**ADDENDUM  
NO. 02**

**March 14, 2022**

**Warren Central High School Phase 3 Renovation and Addition  
9500 E. 16<sup>th</sup> Street  
Indianapolis, IN 46229**

This Addendum consists of Pages ADD 2-1 through ADD 2- 5, and attached CSO Architects Addendum No. 2 , dated March 13, 2023, consisting of 11 Pages, Specification Section 02 01 00 – Maintenance of Existing Conditions, and Addendum 2 Drawings: C101, C102, C401, C501, C502, C503, LD001, L101, L106, L201, L206, L301, L306, S201PRT, S202PRT, S501, S601, AD201N, A201M, A201N, A202N, A211G, A211M, A211N, A401, A404, A423, A431, A432, A600, A601, A602, A603, A611, A612, A701, A702, A703, A800, A801F, A801J, A801M, A801N, A801P, A801R, A801T, A802F, A802N, A802P, A802R, A802T, A900A, A900B, A901K, A902U, A903, A904, A905, A906, MD201F, MD201H, MD201J, MD201K, MD201L, MD202HJ, MD202N, M201F, M201J, M201K, M201L, M201N, M202HJ, M202N, M211F, M211H, M211J, M211K, M211L, M211N, M212HJ, M301, M303.

3.31 SHEET A601 – INTERIOR ELEVATIONS

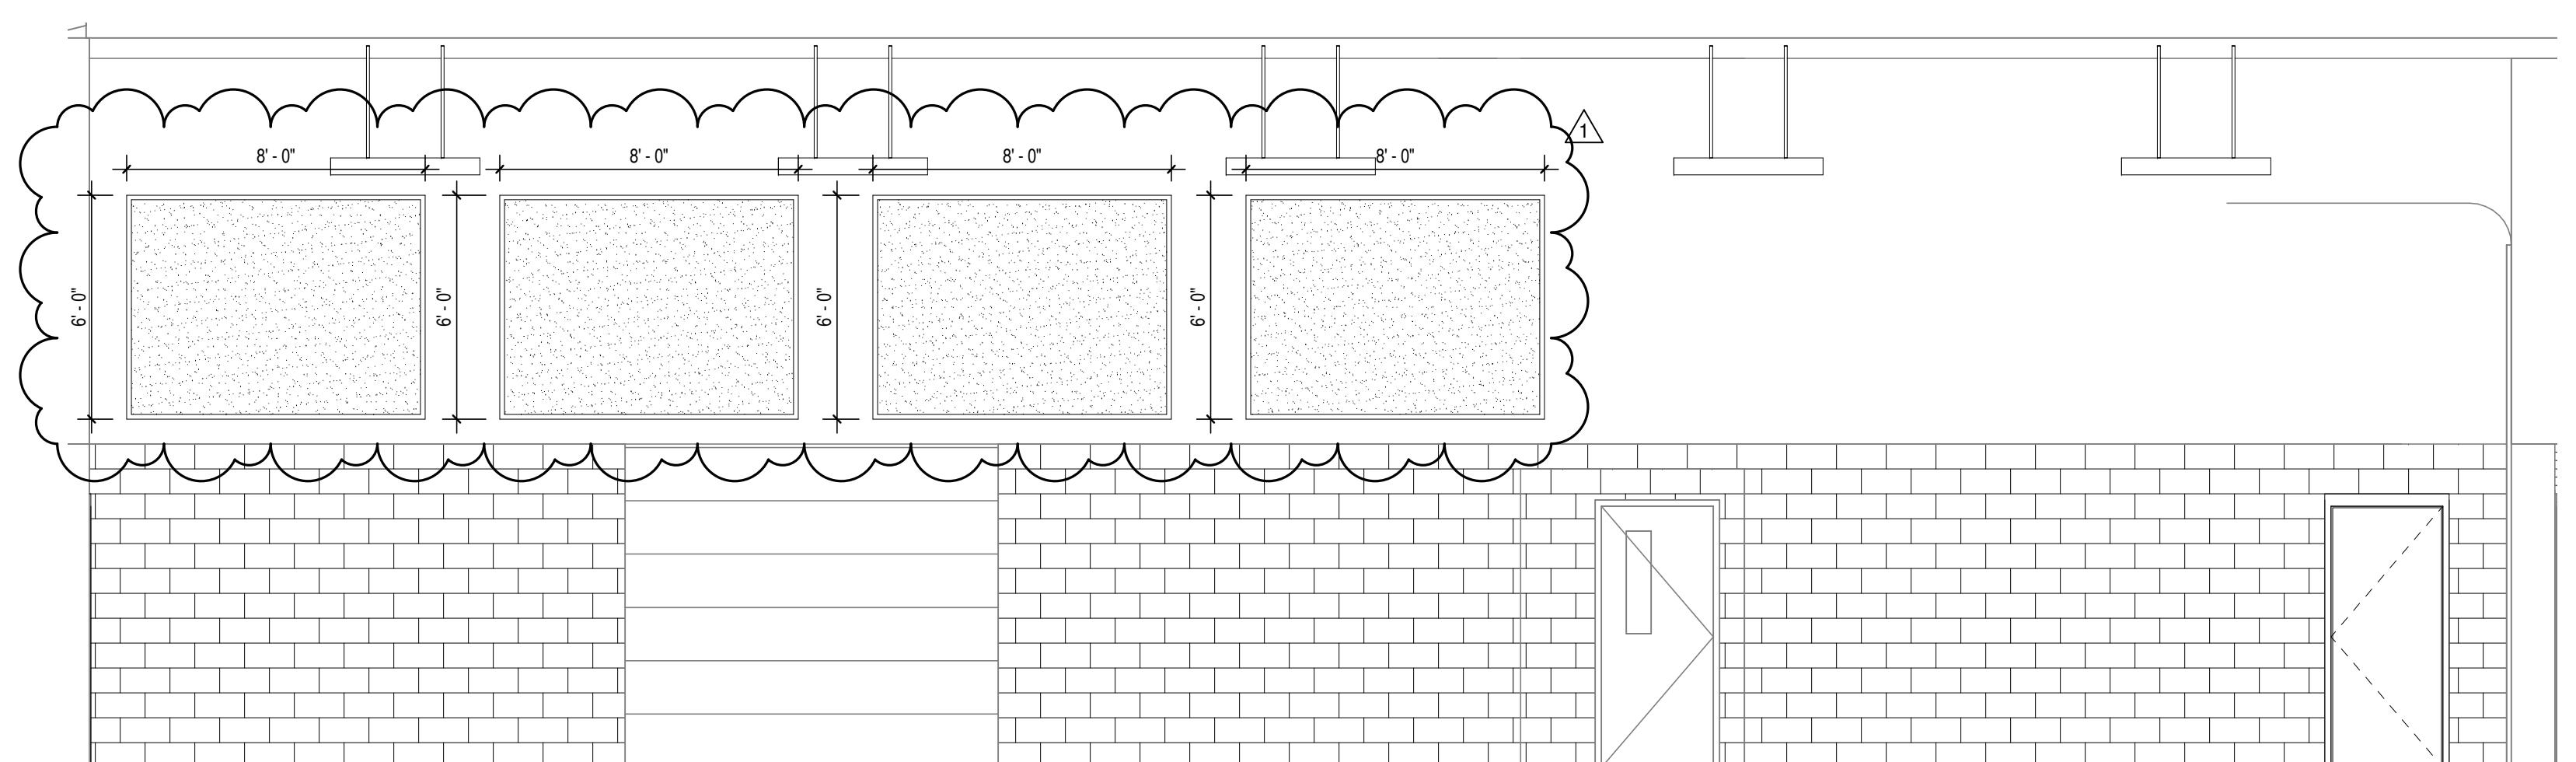
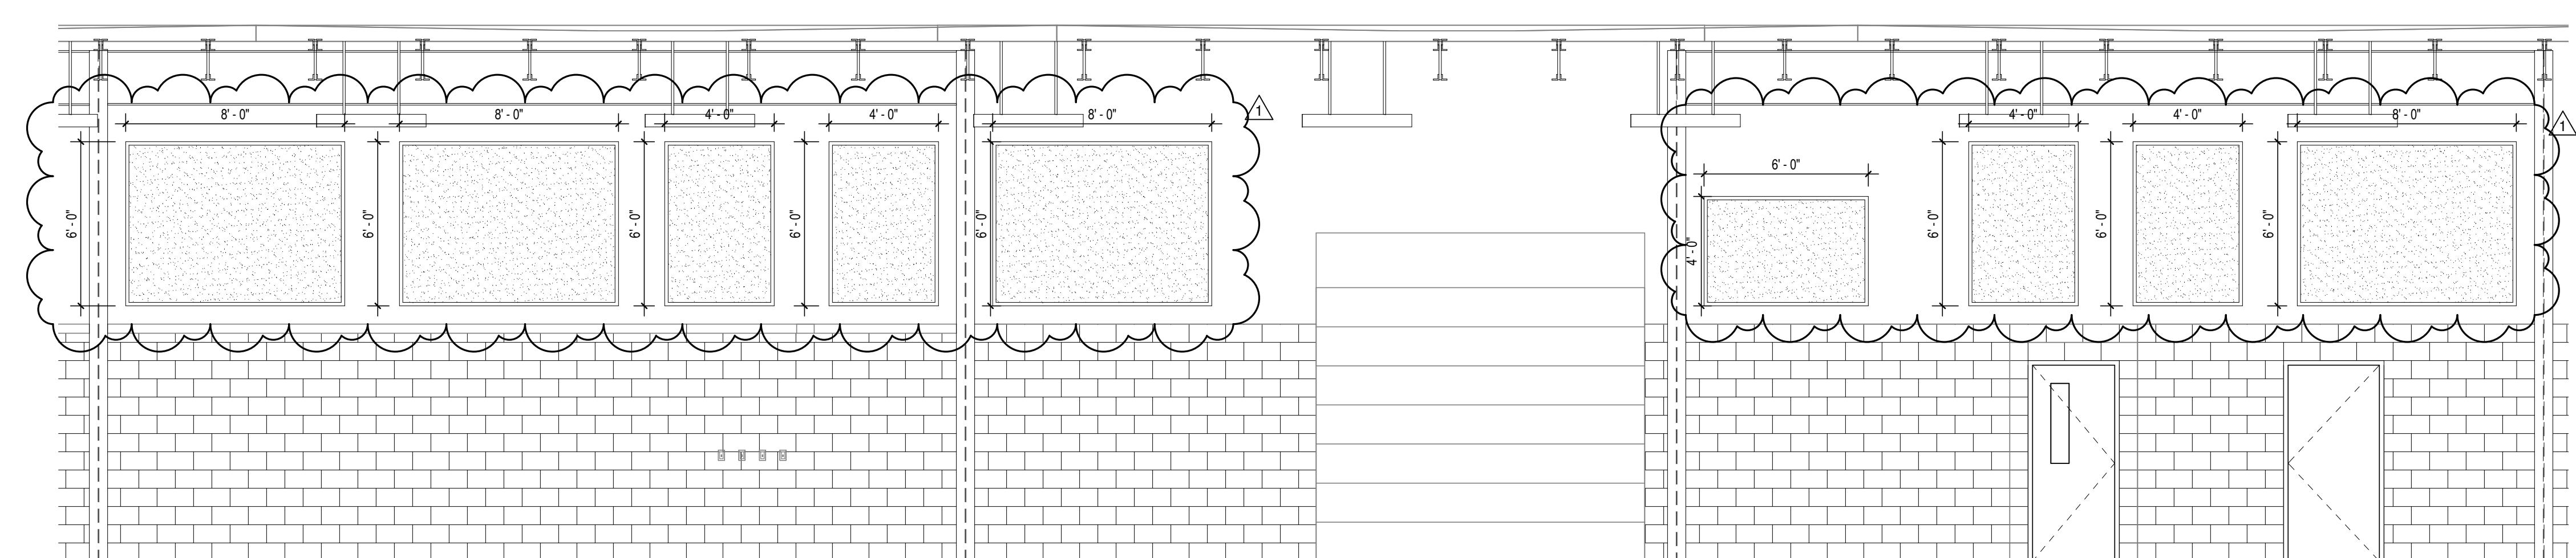
- A. ADD dimensions to acoustic wall panels as indicated on attached re-issued Sheet A601.
- B. REMOVE structural grid lines for clarity.

3.32 SHEET A602 – INTERIOR ELEVATIONS

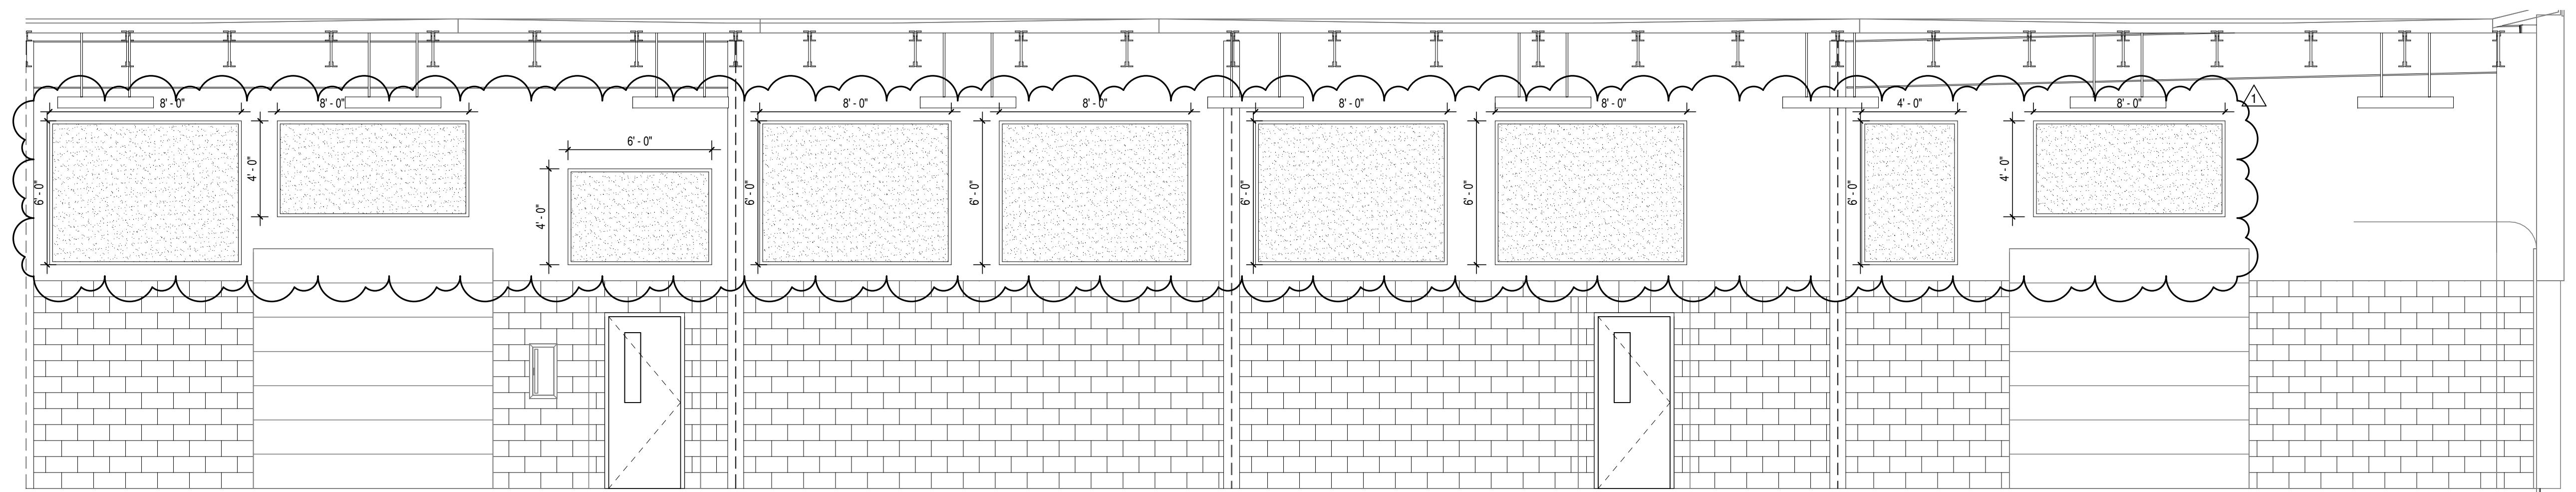
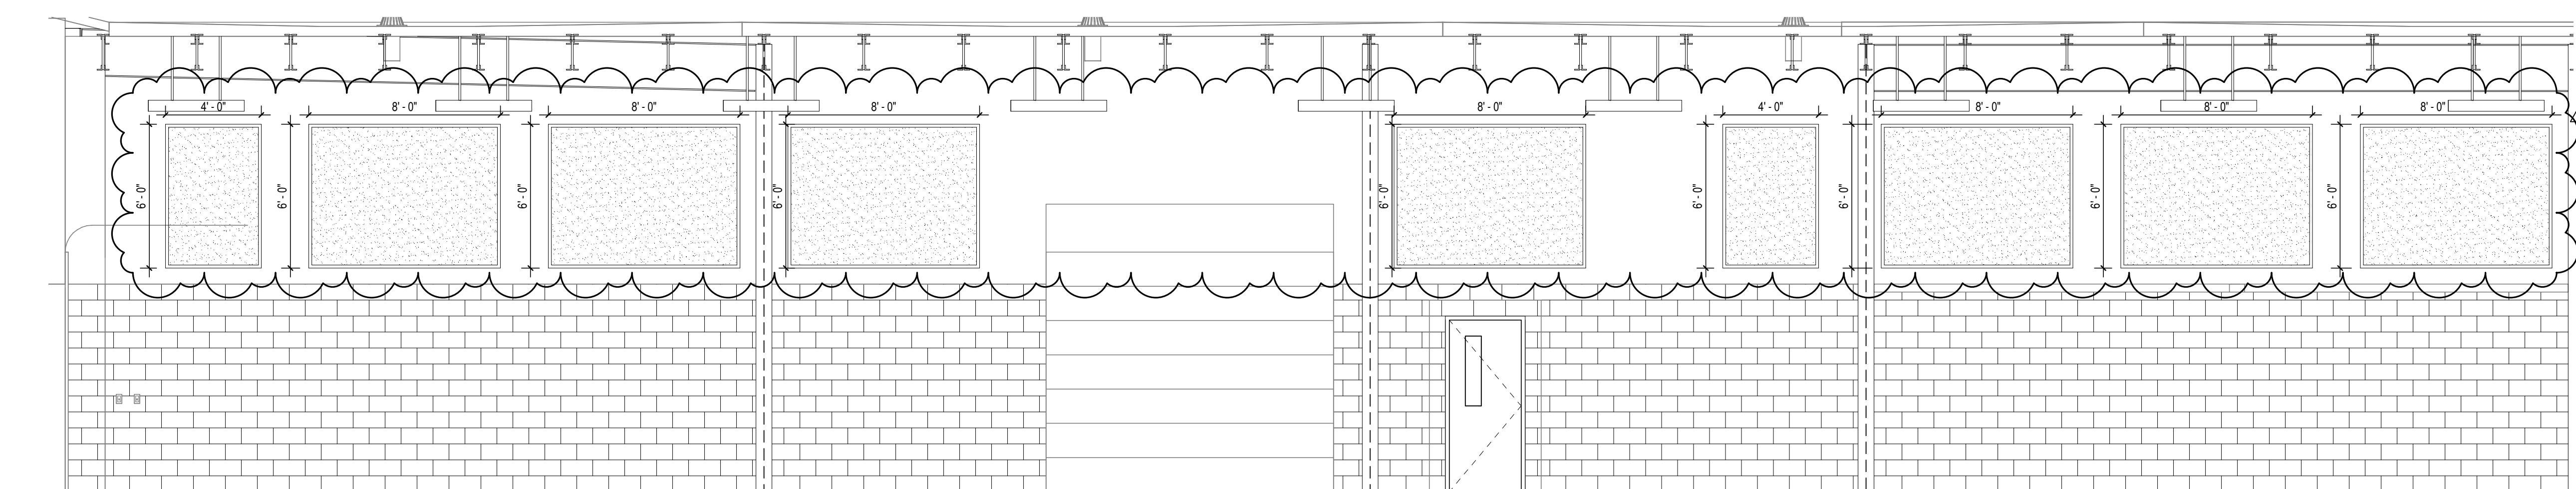
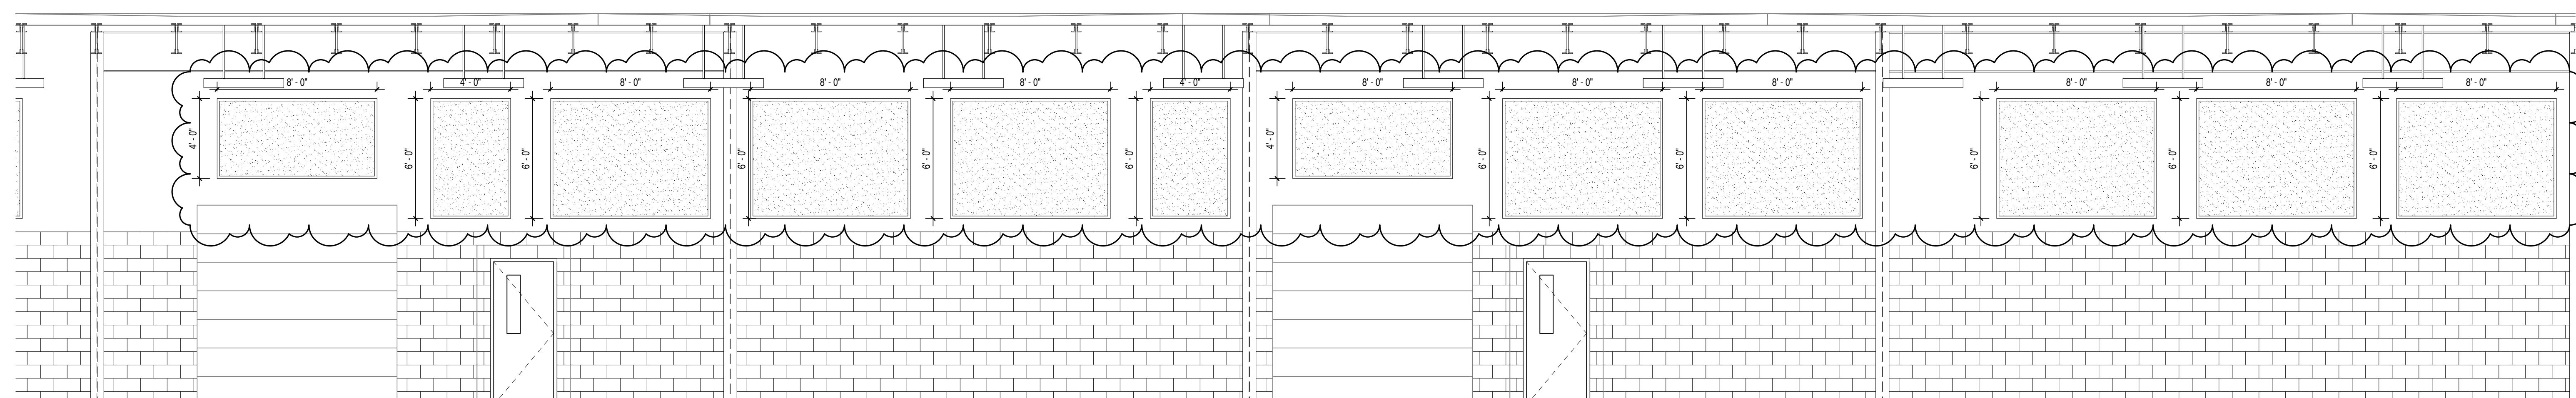
- A. ADD dimensions to acoustic wall panels as indicated on attached re-issued Sheet A602.
- B. REMOVE structural grid lines for clarity.

3.33 SHEET A603 – INTERIOR ELEVATIONS

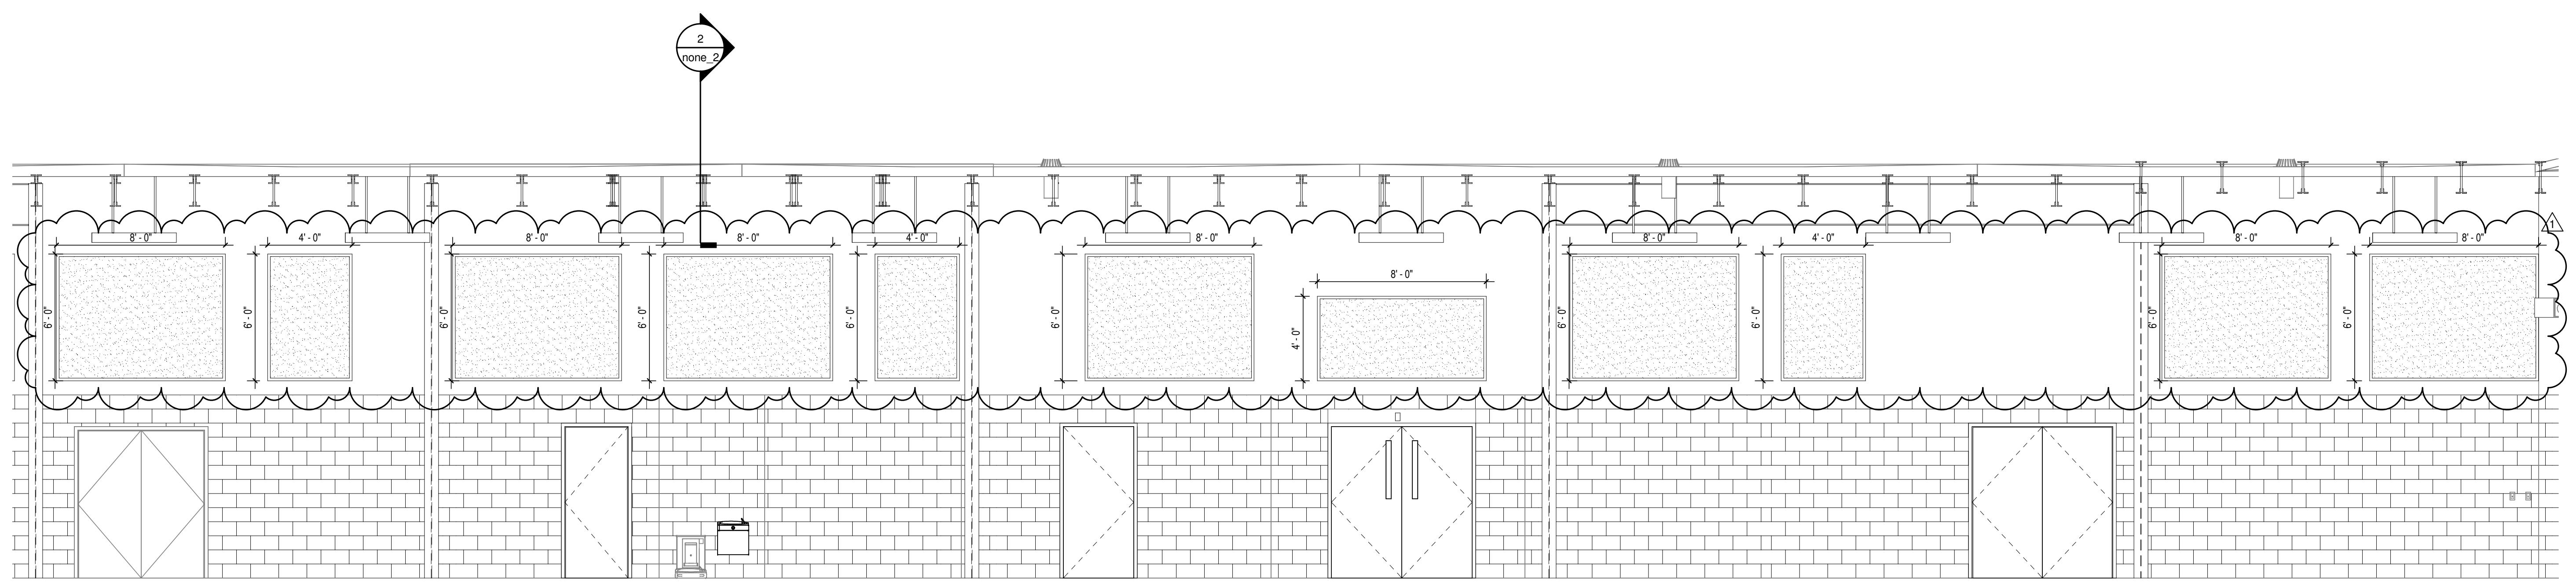
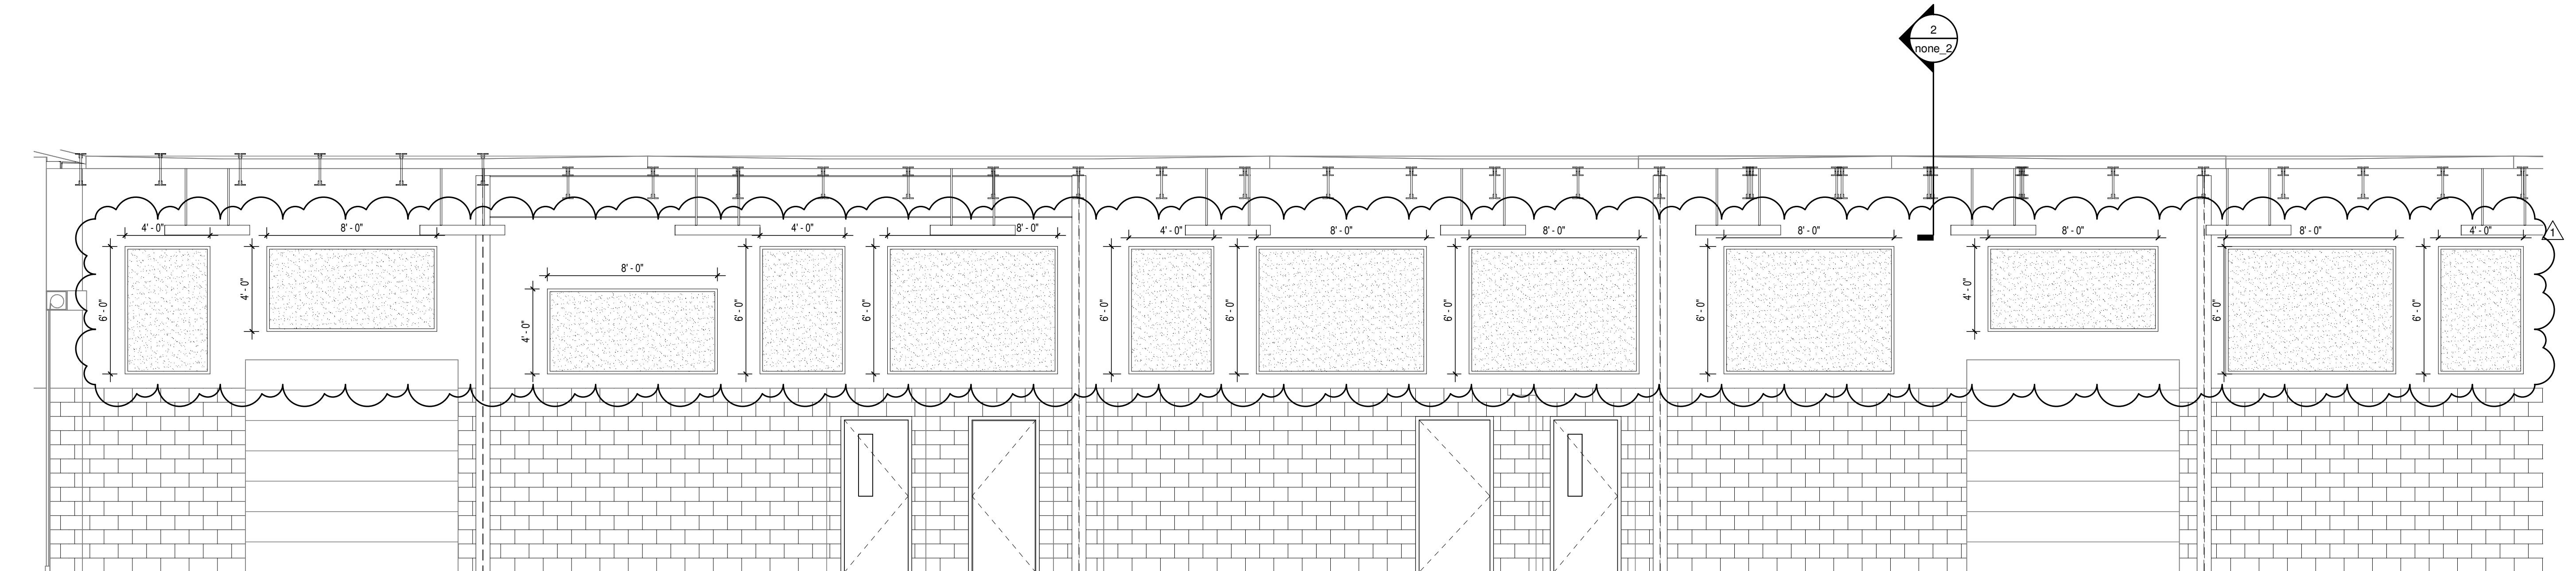
- A. ADD dimensions to acoustic wall panels as indicated on attached re-issued Sheet A603.
- B. REMOVE structural grid lines for clarity.
